***MODIFICATION REQUEST:  
Enfield Intermodal Logistics Centre***

***New masterplan, including change of use  
and operations for some precincts***

***MP05\_0147 (MOD 14)***

Secretary's Environmental Assessment Report  
Section 75W of the  
*Environmental Planning and Assessment Act 1979*

**Figure 2: Masterplan**

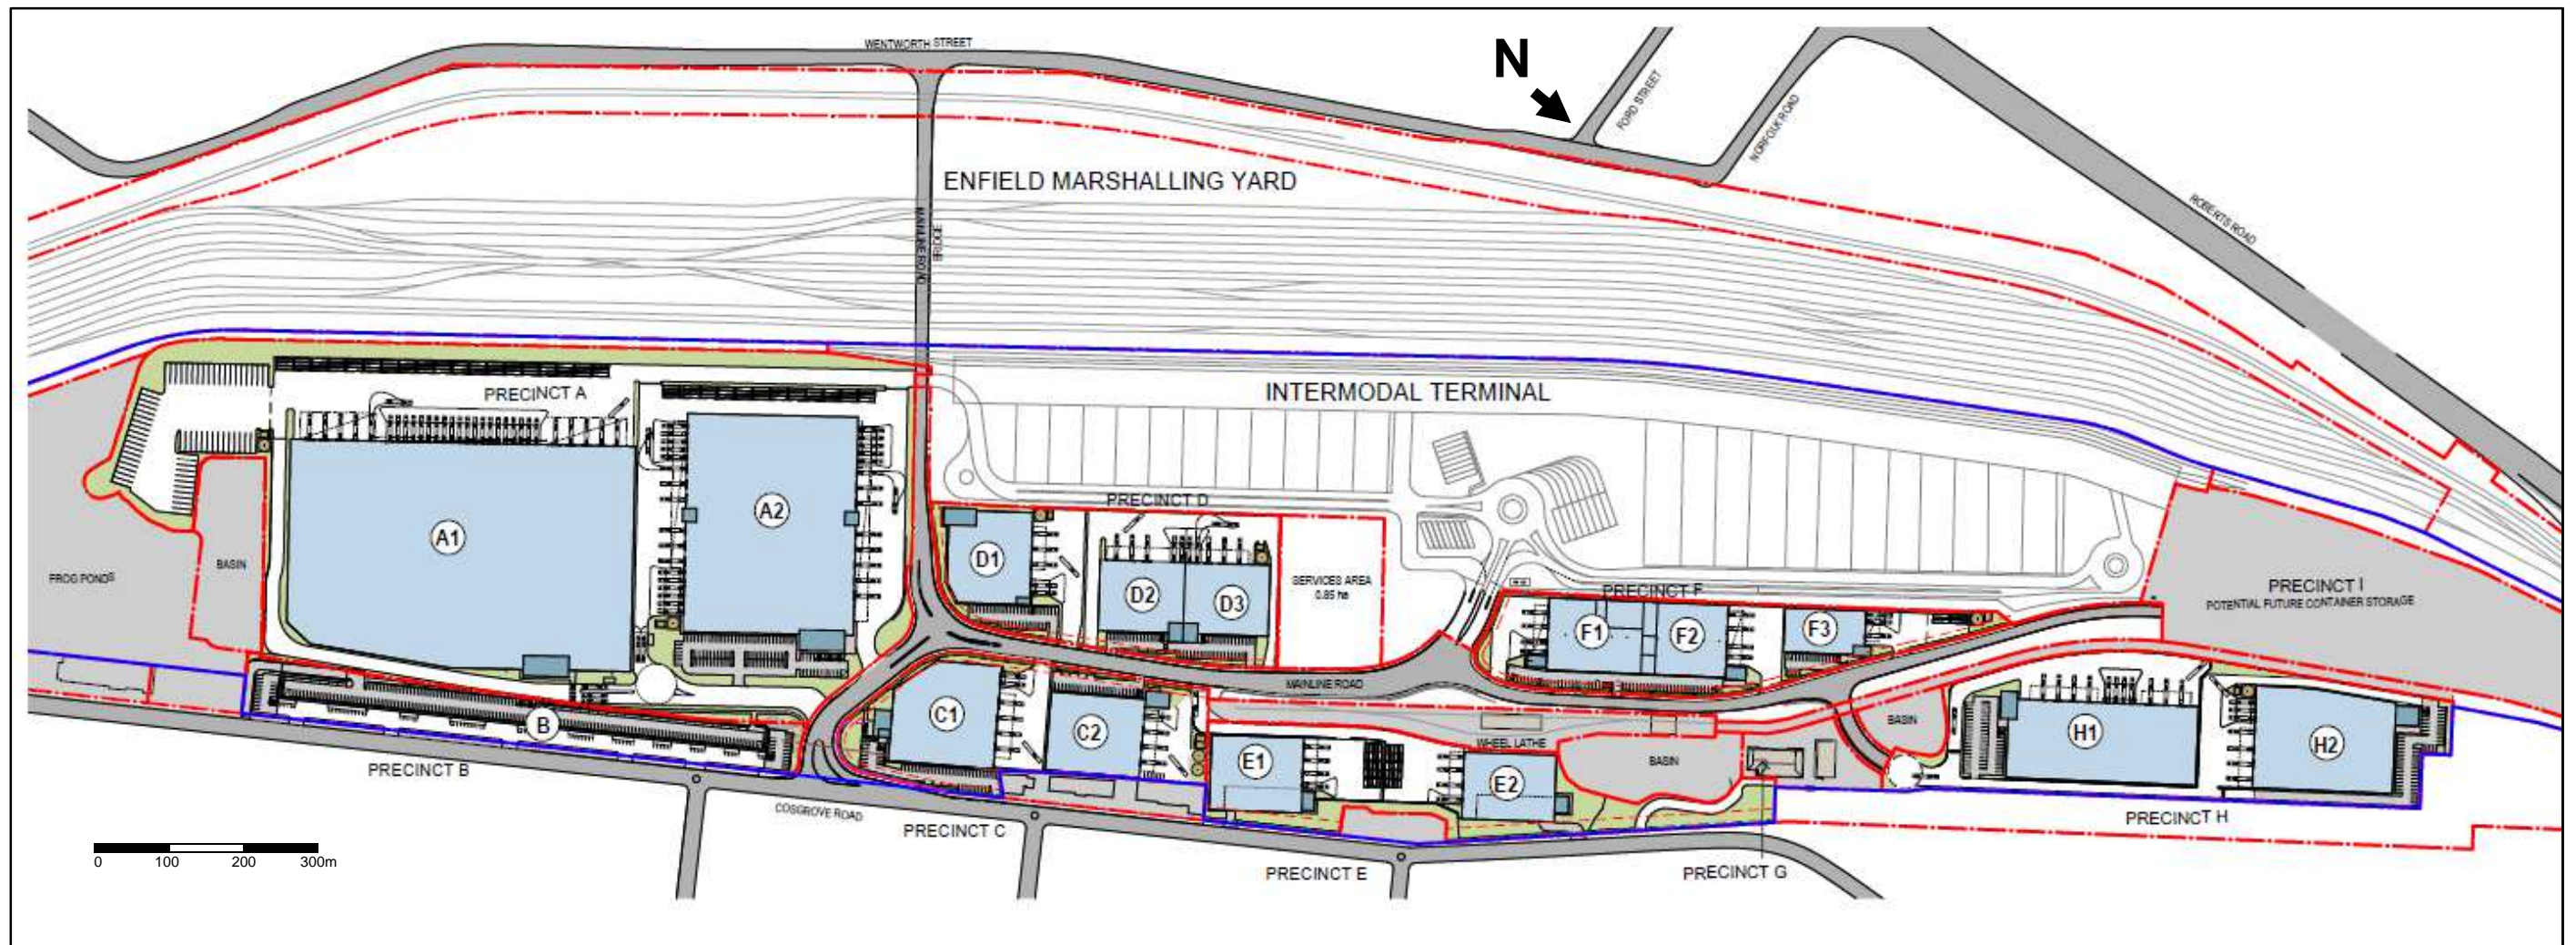
The proposed masterplan for the site, including proposed warehouse layout, is shown in **Figure 2**. A breakdown of the site area into the proposed precincts is provided in **Table 2**.

**Figure 3: Key local intersections**

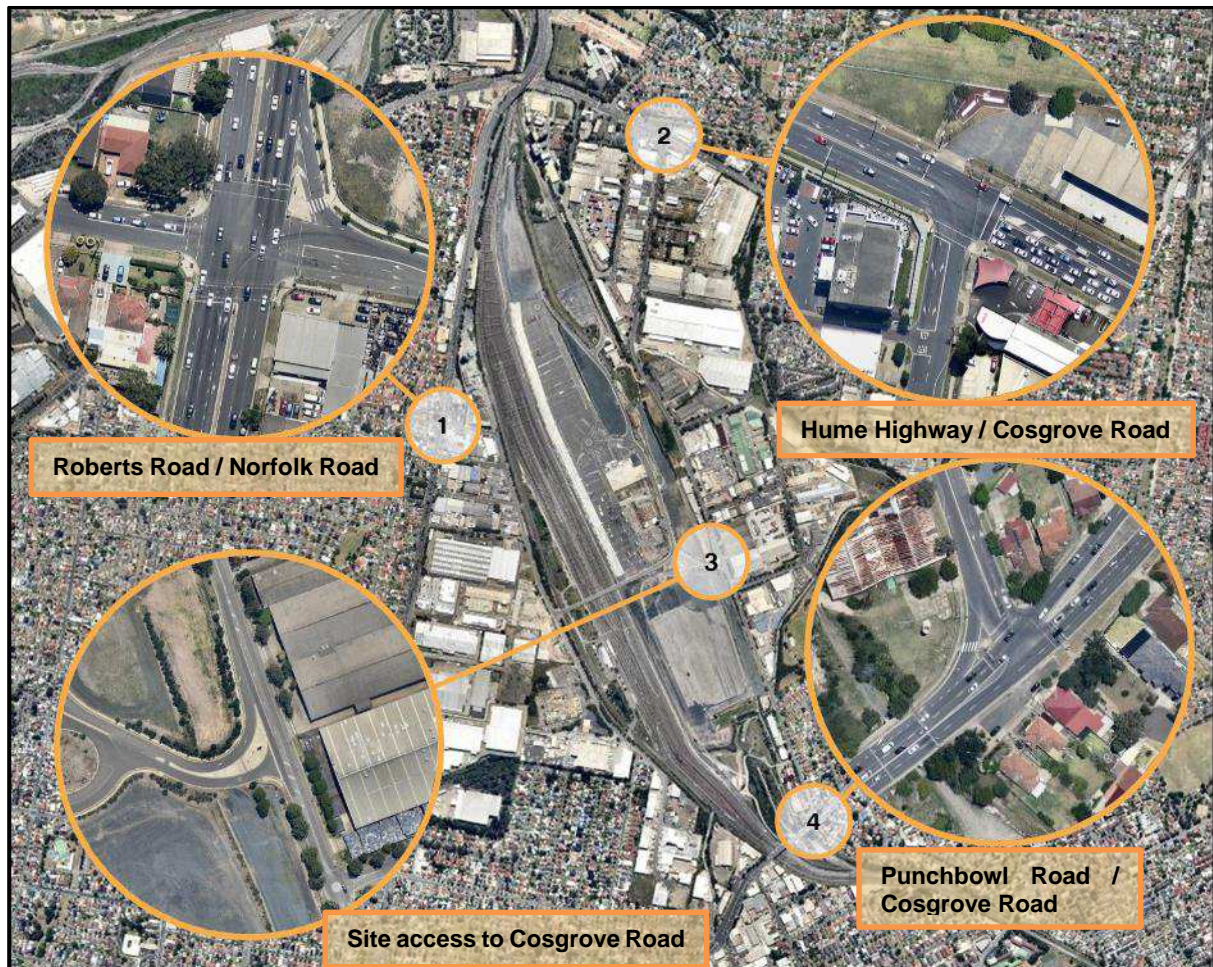
The traffic assessment identifies the key intersections for accessing the site as Roberts Road/Norfolk Road and Hume Highway/Cosgrove Road intersections. The Roberts Road/Norfolk Road intersection is located to the west of the site, while the Hume Highway/Cosgrove Road intersection is to the east of the site. Currently heavy vehicle traffic exiting the site from Turnout Drive (an internal road) into Cosgrove Road is only allowed to enter by turning right (i.e. heading south from Hume Highway) and exit by turning left (i.e. towards the Hume Highway), effectively restricting heavy vehicle movements along the residential area fronting Cosgrove Road north of Punchbowl Road. Key intersections are shown in **Figure 3**.

The proposed changes to the traffic network volumes would generally reduce the average delays at surrounding intersections except for the Roberts Road / Norfolk Road intersection, with an increase of 0.3 seconds in AM peak and 0.2 seconds in PM peak. This increase is considered to be negligible, given the already degraded performance of the intersection.

The Department agrees with the view that the potential traffic impacts from the operation of the site as modified are unlikely to cause excess congestion on the surrounding road network. However, the Department also agrees Council's submission reiterating the importance of managing traffic performance during operation of the project.

**Figure 5: Viewpoint analysis**  
Base source: Enfield Intermodal Logistics Centre — Landscape character and visual impact assessment (CLOUSTON Associates 2018)

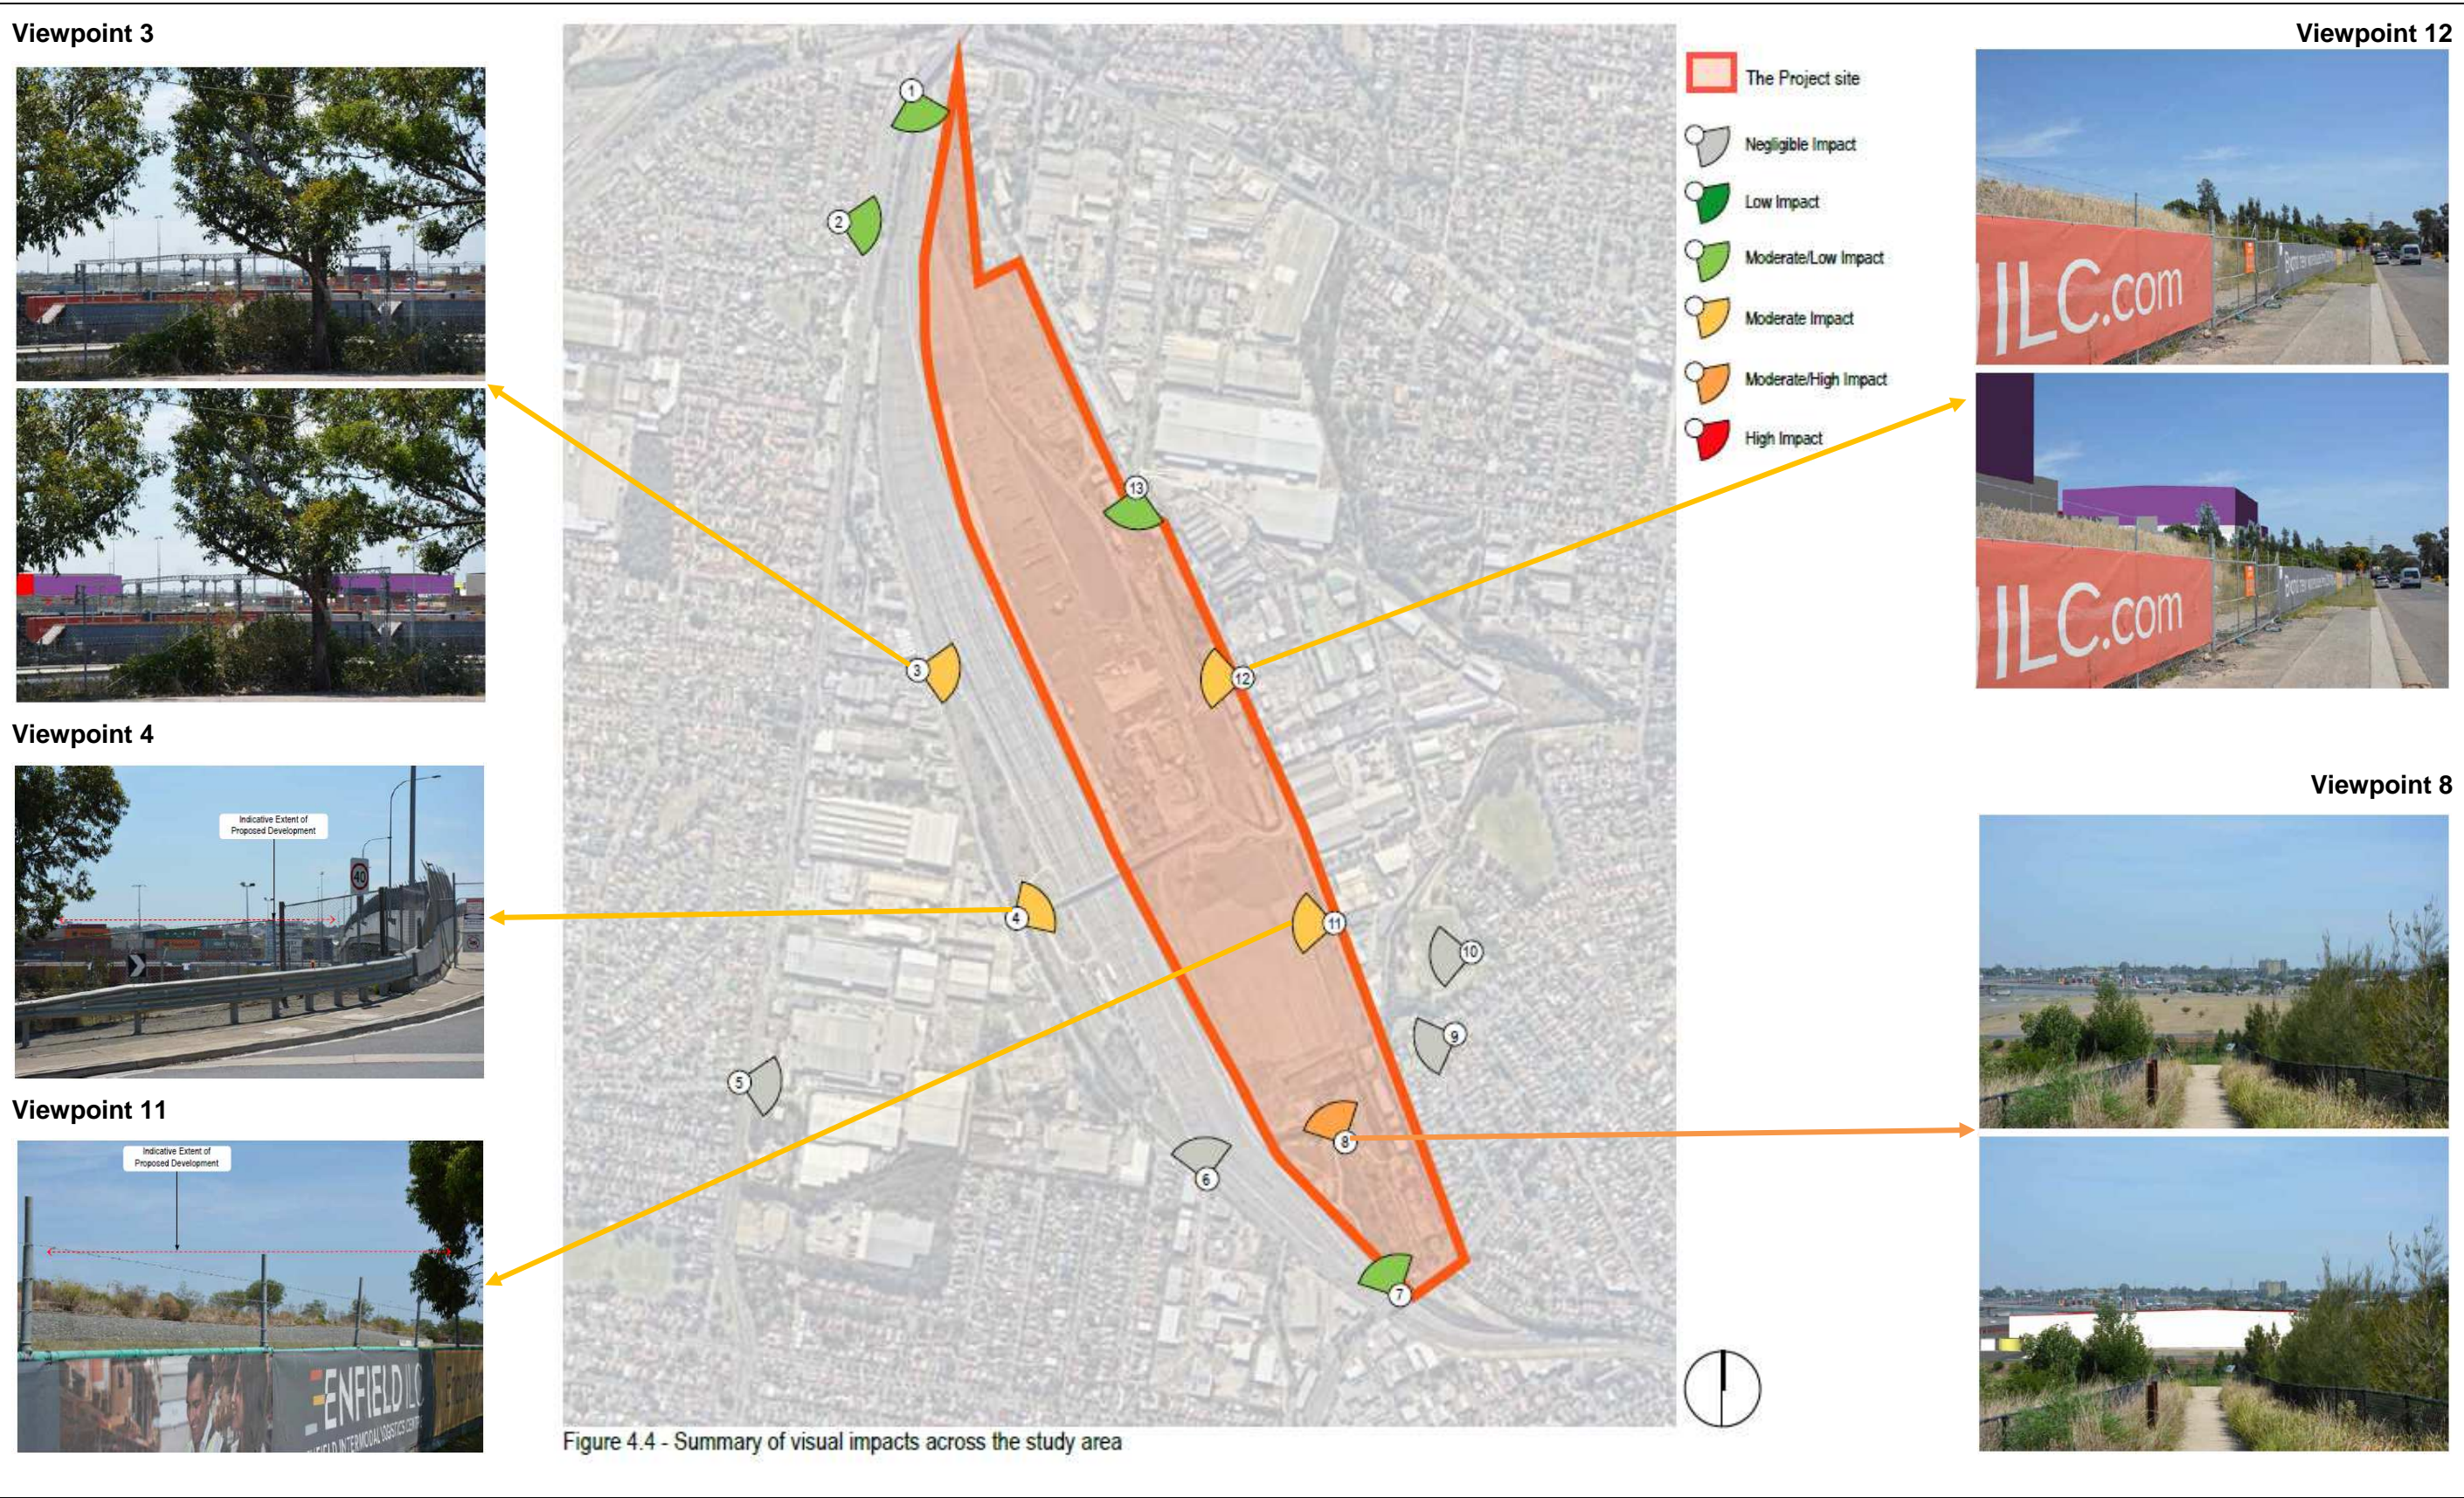
The Proponent conducted a visual impact assessment based on the revised warehousing layout and form, to inform whether the additional heights could be acceptable. The assessment considered impacts of the proposed built form from 12 representative viewpoints, including from recreation areas in the vicinity of the project and residential areas near the site, in Blanche Street, Belfield (east of the site), Bellfrog Street, Greenacre (south-west of the site), and Jean Street and Rawson Road, Greenacre. An additional viewpoint on Mt Enfield would be impacted to a greater (i.e. moderate/high) degree, but the purpose of that site is to provide a lookout point over the project, and changes to the view would not be characterised as a negative amenity impact. The results of the assessment are shown in **Figure 5**.

The Department considers it remains appropriate that the Proponent be able to further refine its design and submit for review and approval after determination of this modification, so long as it remains generally consistent with the parameters of the conditions.
